Re: Walgreens – Big Boy – Conceptual – 1st Review
SP No. 08-03
OHM Job No. 163-08-0024

PLAN REVIEW CENTER REPORT
March 12, 2008
Planned Rezoning Landscape Review
Walgreens SP#08-03

Re: **FACADE ORDINANCE – Revised Pre-Application Facade Review**
Walgreens Store (Haggerty Rd. and Eight Mile Rd.)
Façade Region: 1
Zoning District: FS (Proposed: B-3)
Project Data: One building – 13,824 Sq. Ft.

RE: Walgreens / Eight Mile & Haggerty, SP08-03, Conceptual/PRO
Fire Department

CONCEPTUAL
SITE PLAN

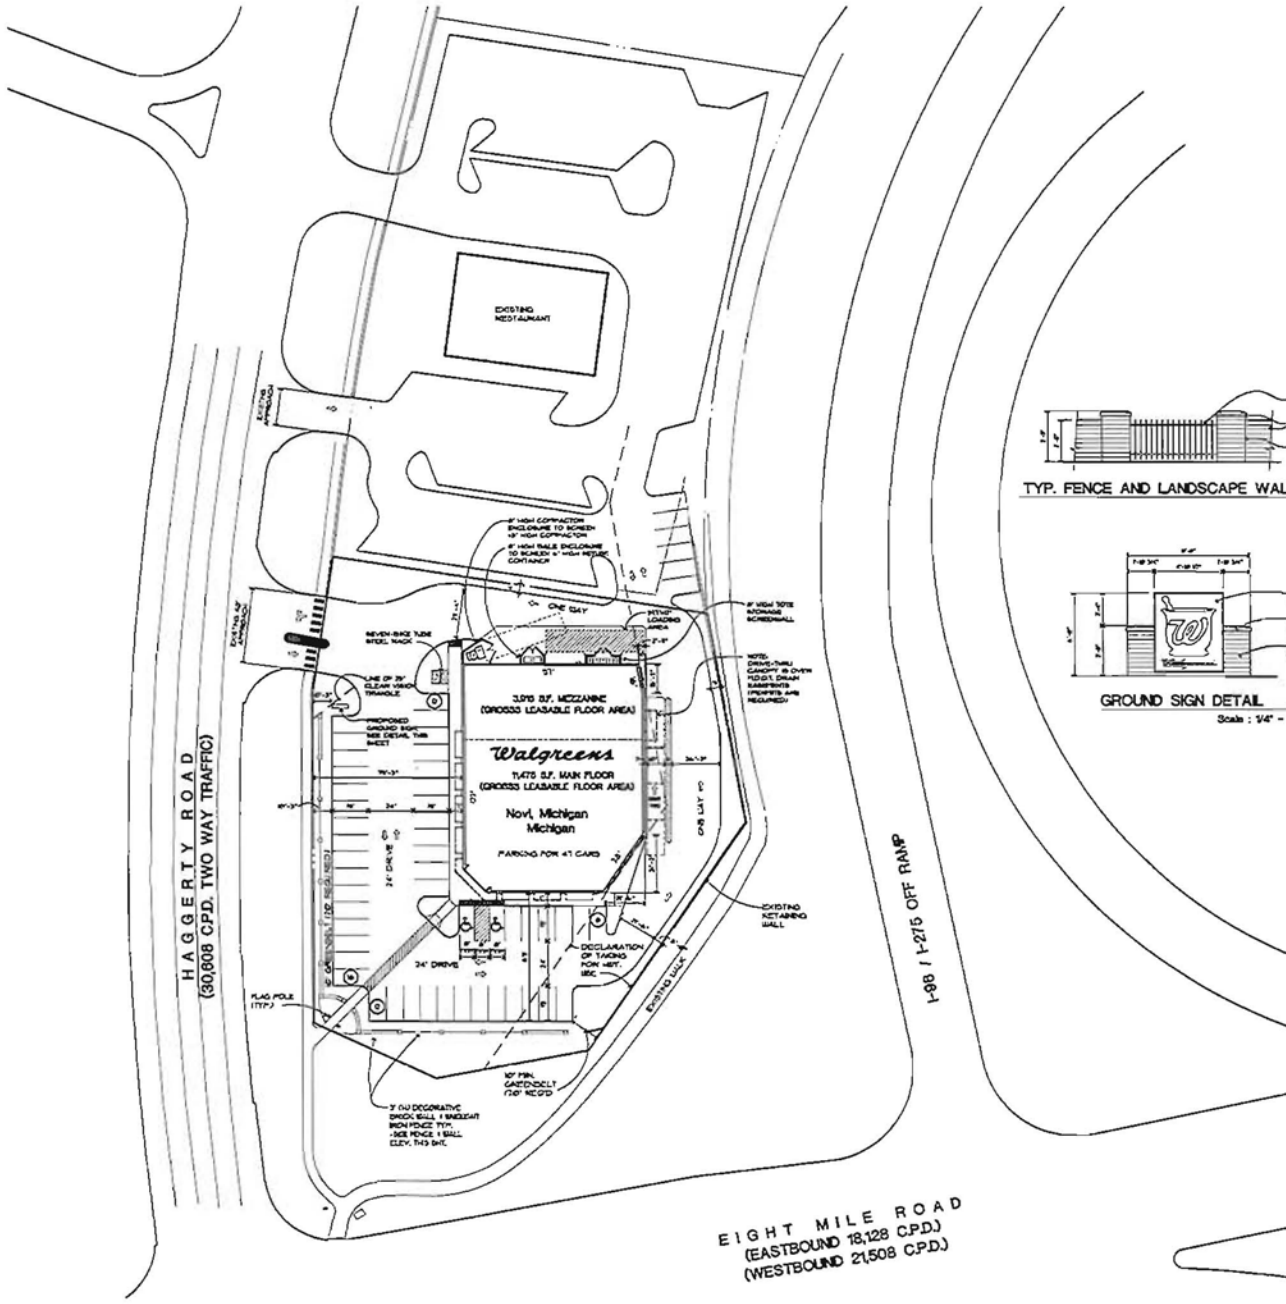
1. Dimensions: Following dimensions should be noted on the site plan:
 - Minimum width of the one-way circulation aisle north of the loading zone.
 - Width of the concrete sidewalk north of the barrier free parking spaces. Such dimension should be at least 7' to account for the 2' overhang by the parked vehicles.

- Clear distance of the barrier free parking signs from the edge of the sidewalk. At least 2' clear distance should be provided to account for the 2' overhang by the parked vehicles.

2. Parking Calculations: We noticed that the total parking spaces provided are less than the required by the City of Novi ordinance.
3. Sidewalk: At the point where the site driveway crosses the sidewalk along Haggerty Road, the plans show the ADA ramps being provided to cross the driveway. However, the correct design practice for minor access points is that the sidewalk is to be continued through the driveway, to denote the fact that pedestrians have priority over driveway traffic.

4. Signs: NO PARKING FIRE LANE (R7-9a mod) signs along the one-way circulation aisle should be placed facing the direction of traffic.
5. Sign Details: A 7' mounting height from the bottom to the parent sign should be provided for all the traffic signs.

6. Handicapped Pavement Marking: The term "International Access" symbol for the handicapped pavement markings should be replaced by "MMUTCD" symbol.

1. A 20' wide greenbelt is required adjacent to parking. The Applicant has provided a 10' greenbelt along Haggerty and as little as 5' along the MDOT right-of-way. **The reduced greenbelt size would require a approval of a deviation from ordinance standards in the PRO Agreement.** Greenbelt Canopy and Sub-canopy Trees have been provided per Ordinance requirements.

2. A 3' high berm with a 2' crest is required along public and private road frontages adjacent to parking or vehicular access areas. The Applicant has chosen to request a 36" high masonry wall, brick pillars and wrought iron fencing in place of the berm along the Haggerty Road and Eight Mile Road frontages. Please note that the Eight Mile side of the property is buffered by distance and the adjacent extended MDOT right-of-way. This area is potential additional planting area should MDOT grant permission. **The use of the proposed walls and decorative fencing in lieu of the berms would require approval of a deviation from ordinance standards in the PRO Agreement.**

1. A total of 1,767 SF of Parking Island Landscape Area is required. The Applicant has provided 800 SF. Please provide the required Parking Island Landscape Area.
Alternately the Applicant could seek a deviation from ordinance standards for that portion of Parking Island Landscape Area.
2. Perimeter Canopy Trees are required at an average of 1 per 35 LF around parking and vehicular access areas. These trees need not be evenly spaced and have been provided per Ordinance requirements.

2. A 4' wide landscape bed is required around the entire building perimeter with the exception of access points. The majority of the building perimeter has been proposed as access pavement. The majority of the building perimeter is planned as pavement. **Please add Foundation Landscape where possible.**

3. A total of 3,264 SF of building foundation landscape area is required (8' x building perimeter). Only 209 SF has been provided. **This would require acceptance of a deviation form the ordinance standards in the PRO Agreement.**
